Docket # 50-284
Accession # 9812150197
Date 12/11/98 of Ltr
Regulatory Docket File

Technical Specifications

Conversion Submittal

**New York Power
Authority**

FIGURE 4.3-1 Pressure/Temperature Limits for Hydrostatic Leak Test

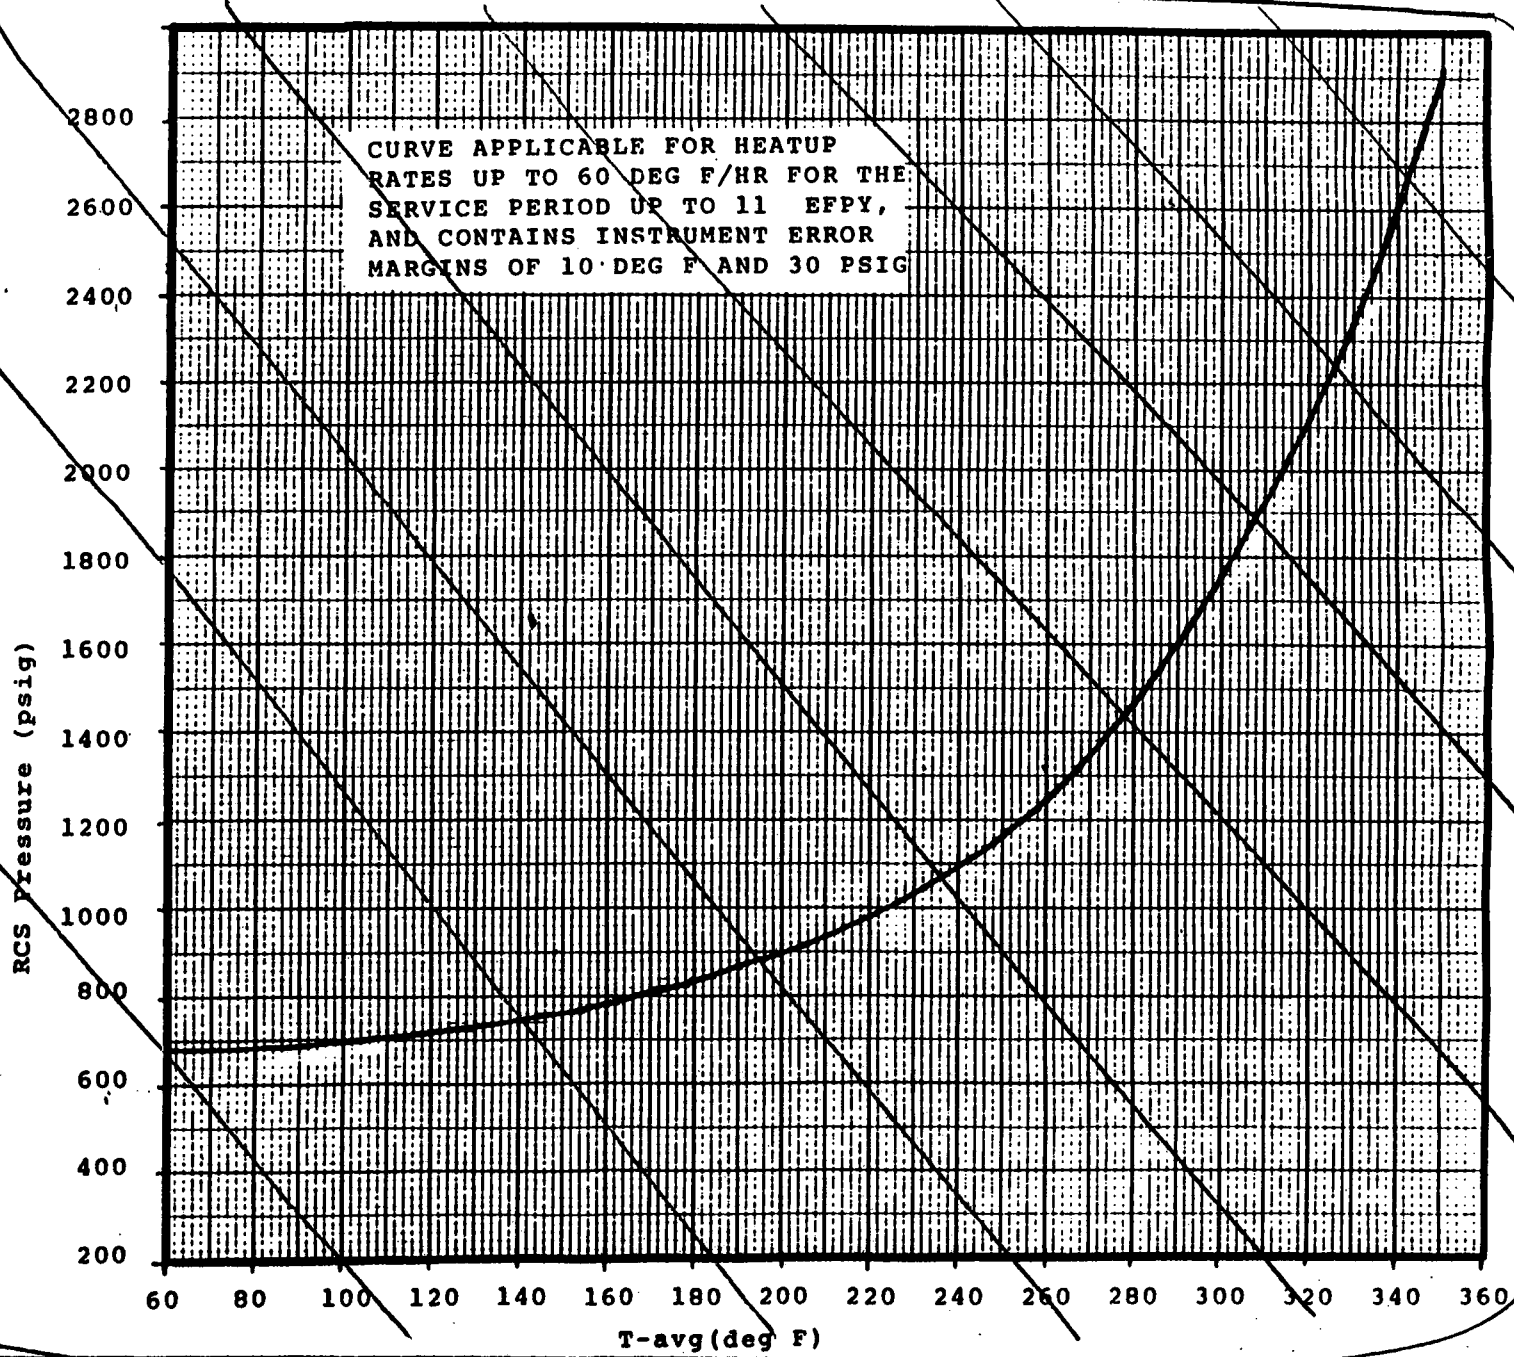
LA.1

ITS 3.4.3

ETS 4.6
TSCR 98-019

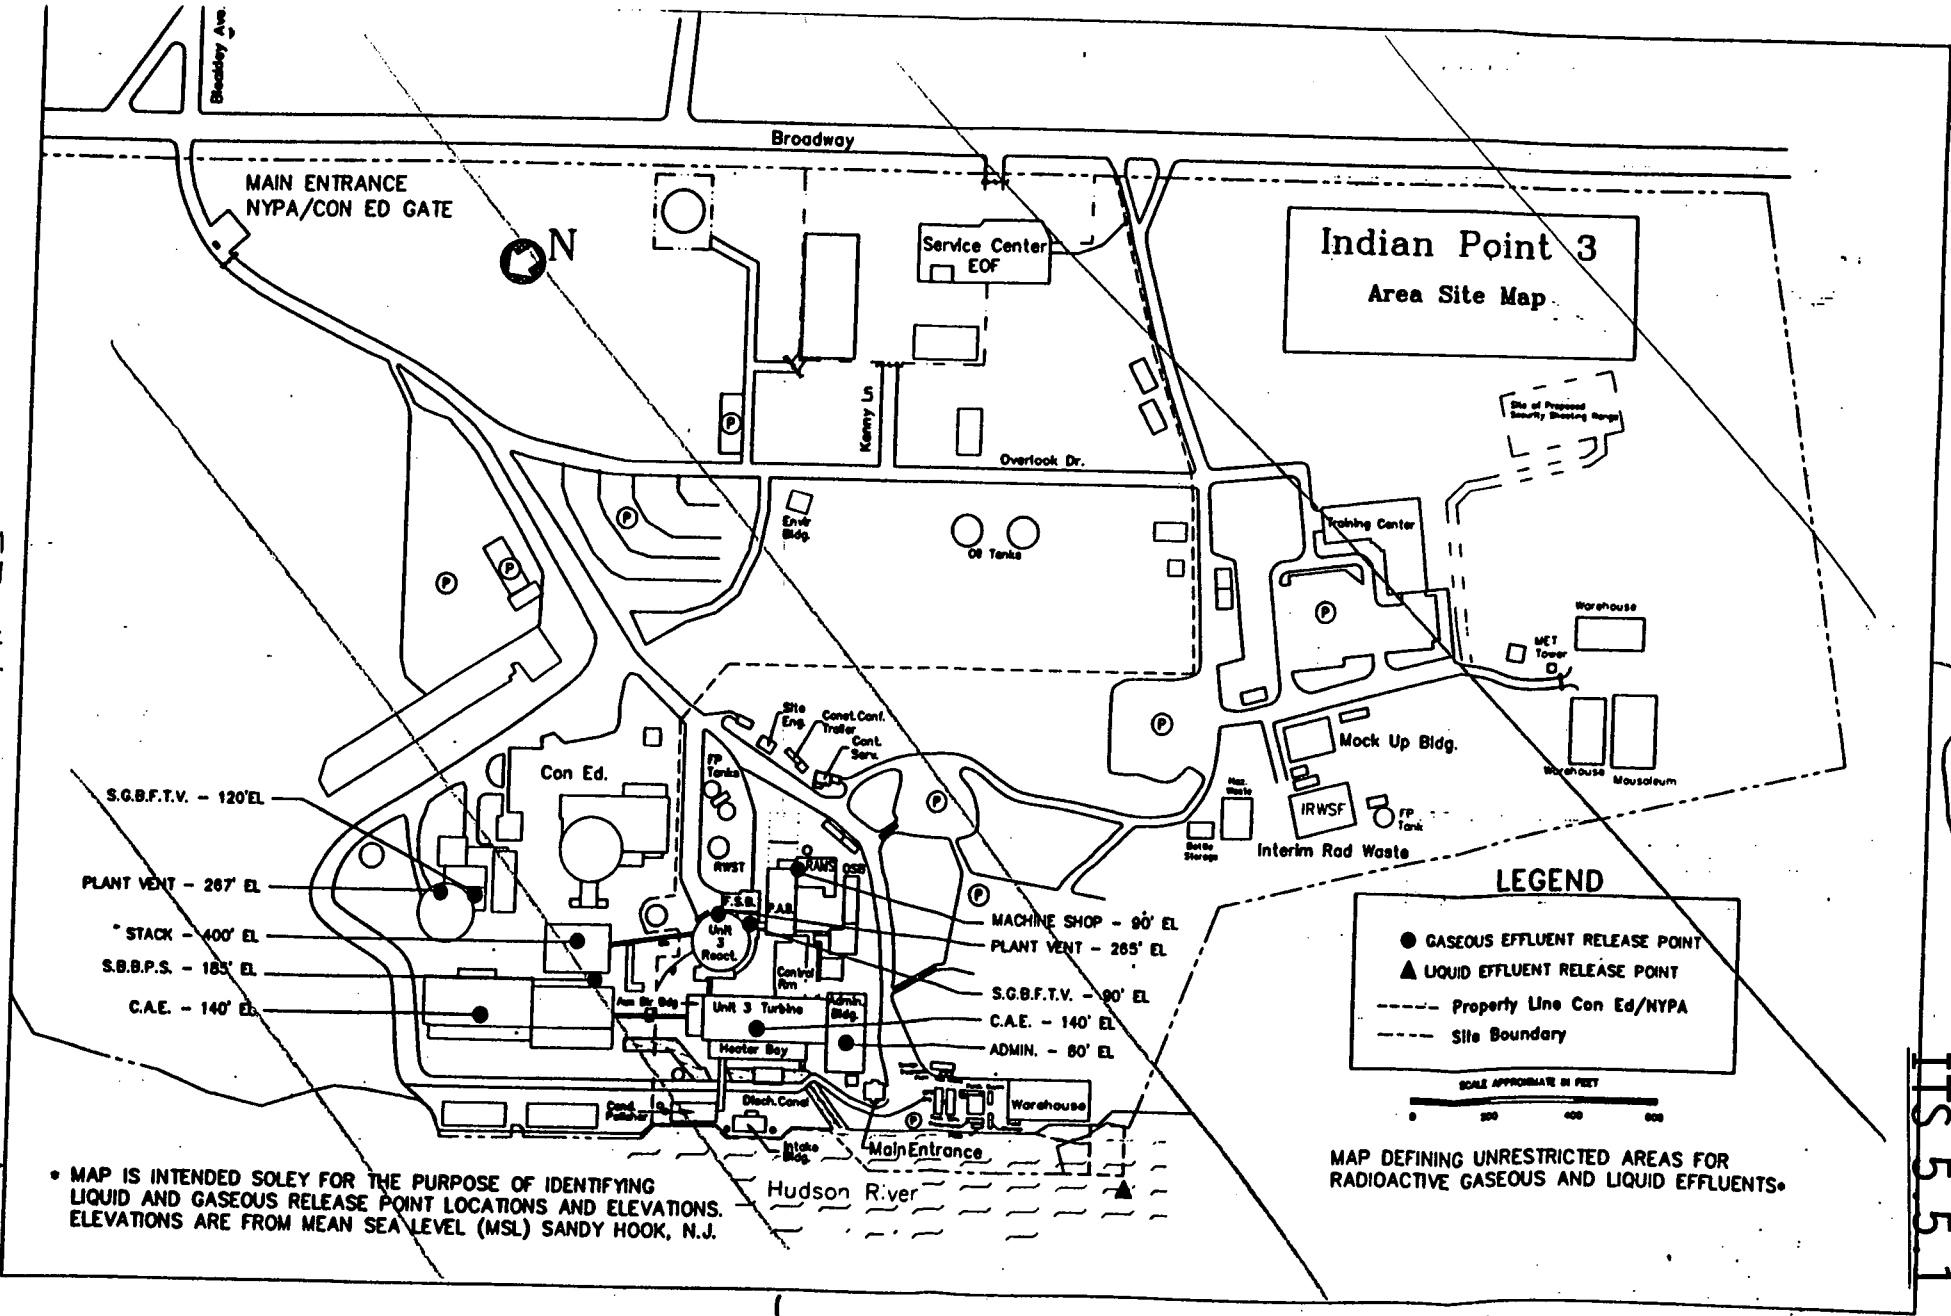
LA.1

ITS 5.5.1
